## PRODUCT CHANGE NOTICE

**PCN#19-063**

**RBP-650+**

Internal redesign of assembly

### Graph comparison:

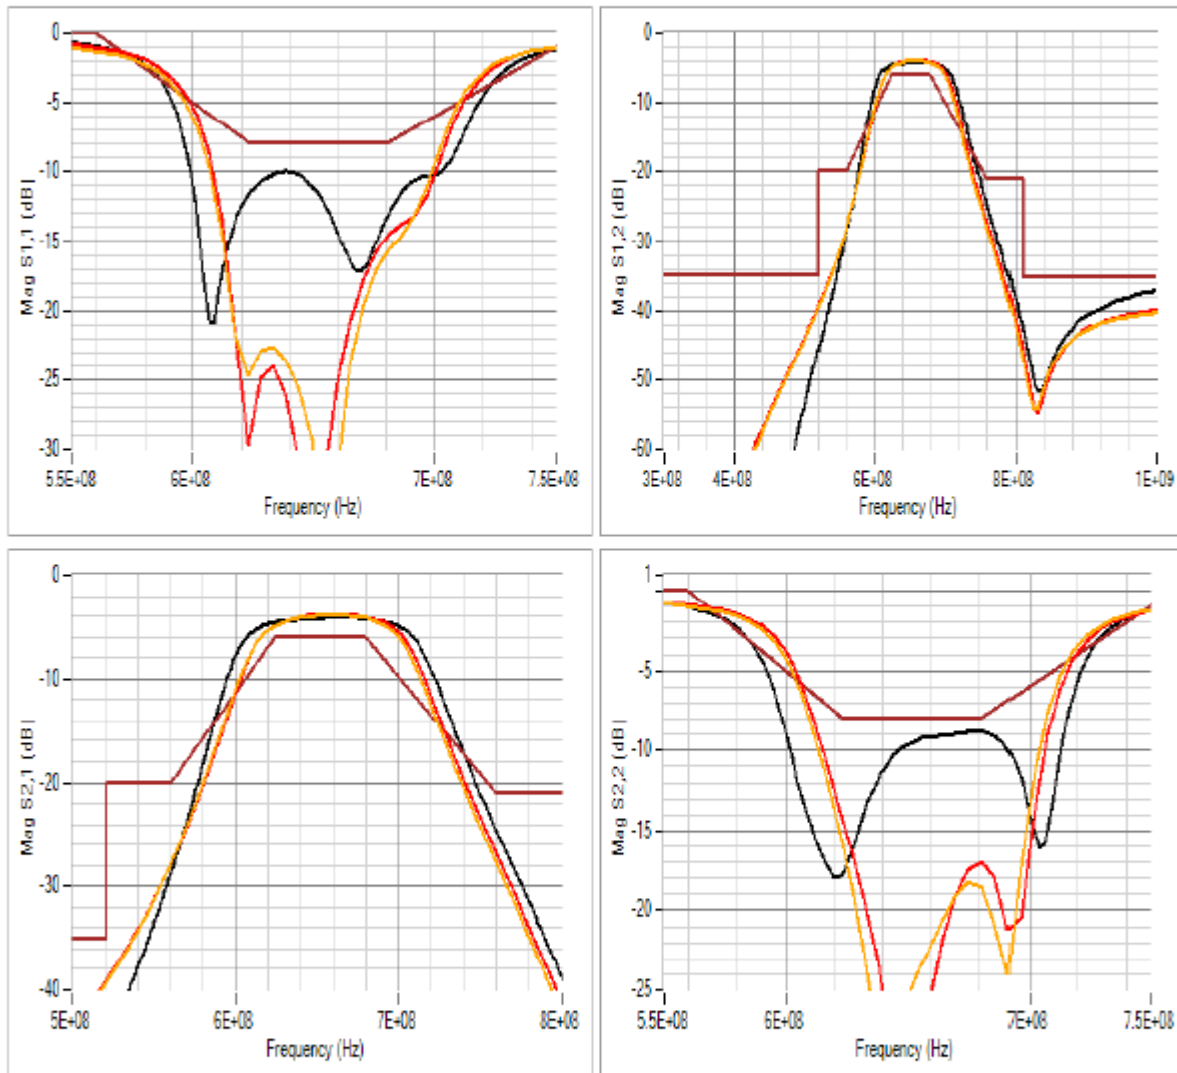
No change to FIT (dimension) or FORM (appearance).  
Change to FUNCTION (performance) within specification

Improved assembly process
